Consultant	Wahib Medanat Consultant Engineer	Rep No.	23-23072022
Contractor	Dijlah Establishment Constr. Contracting	Tender No.	(11/2019/USAID/SKEP/3/S) Schools for a Knowledge Economy Project (SKEP) - Phase (3) Package (1, 2)
Site Name	Jumana Bint Abit Taleb Basic Mixed School - Jerash	Day/ Date	Sat. 23/07/2022
Duration of Project	450 Calendar Days	Total Project Budget	8,314,983.735 JD

Visit Notes

(Figure: 01)

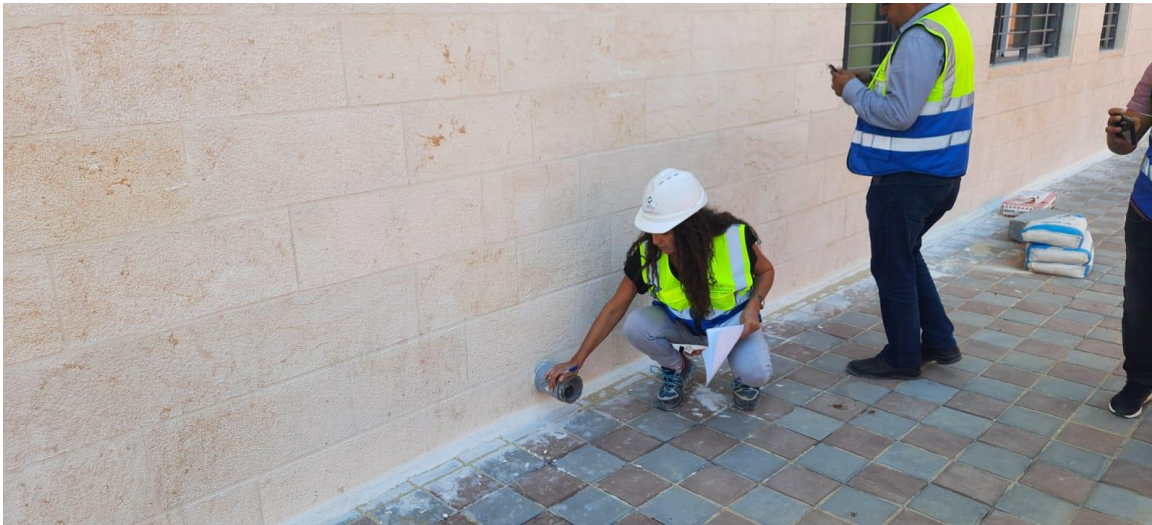
Reduction of the protrusion in the rainwater drainage pipe and executing the slope for the water between the building facade and the sidewalk is required

(Figure: 05)

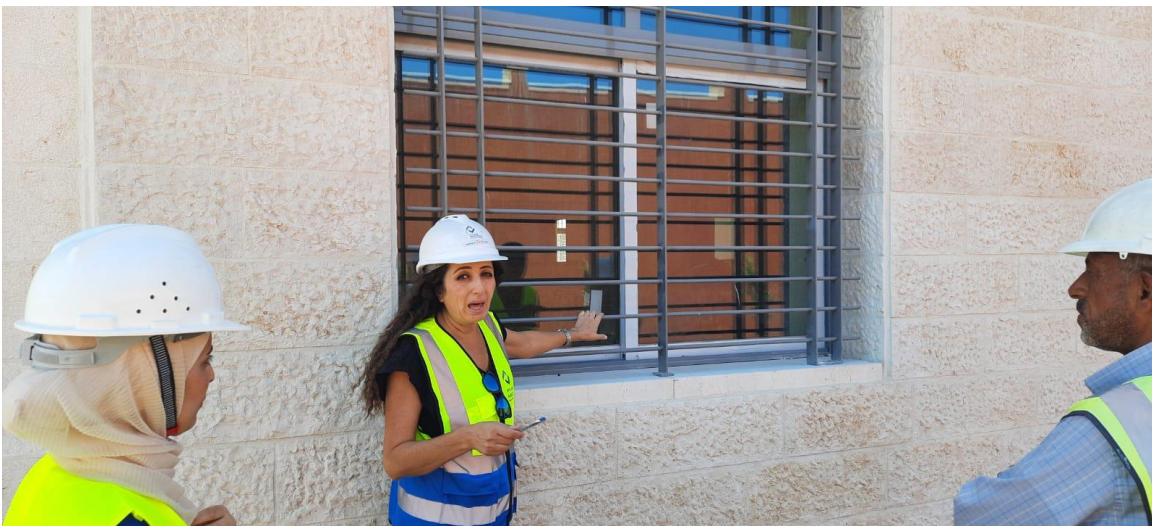
The Contractor used different color of paint for the steel protections screens for a number of windows

The team requested the Contractor to rectify

(Figure: 07)

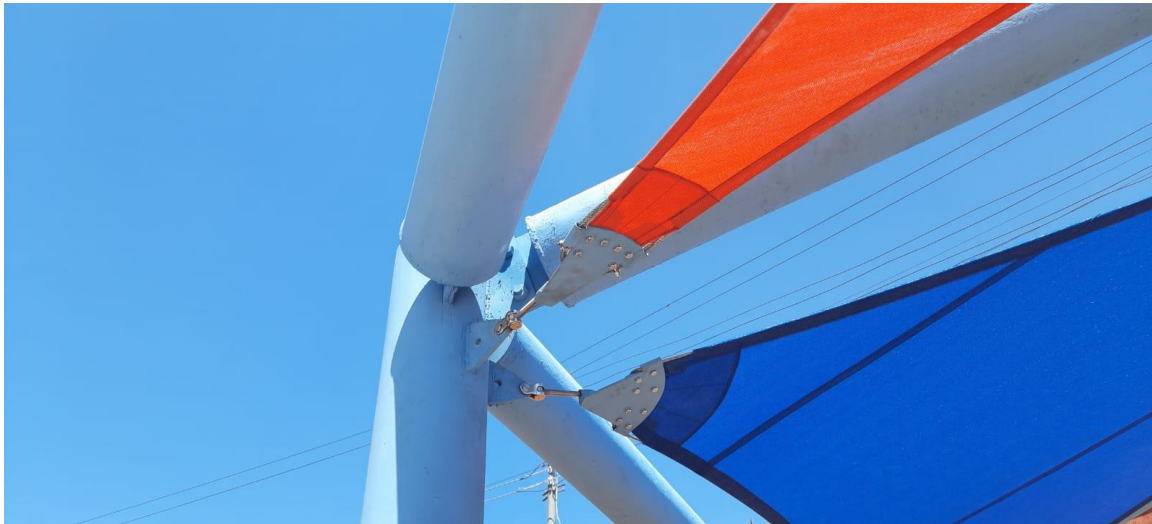
The supervision team observed defects in the painting for the horizontal pipes of the shading. Also the fabric needs more tightening to reduce the movement. The edges of the shading foot at the sand pool needs to be rectified to avoid injuries of the users

(Figure: 17)

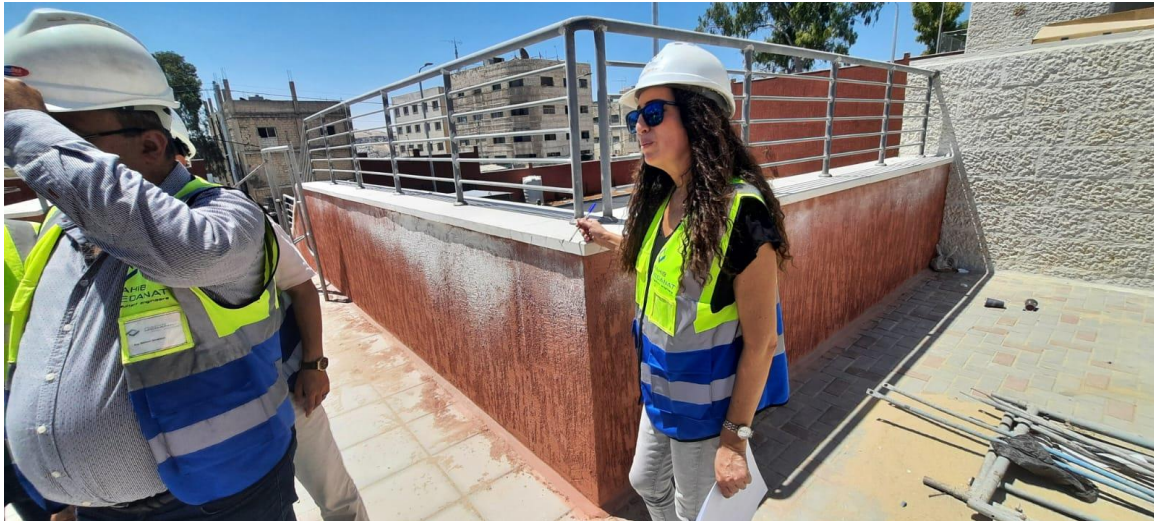
The team observed that the fabric at the shading of the yard is not covering the whole area for protection from the sun. The Contractor was requested to rectify
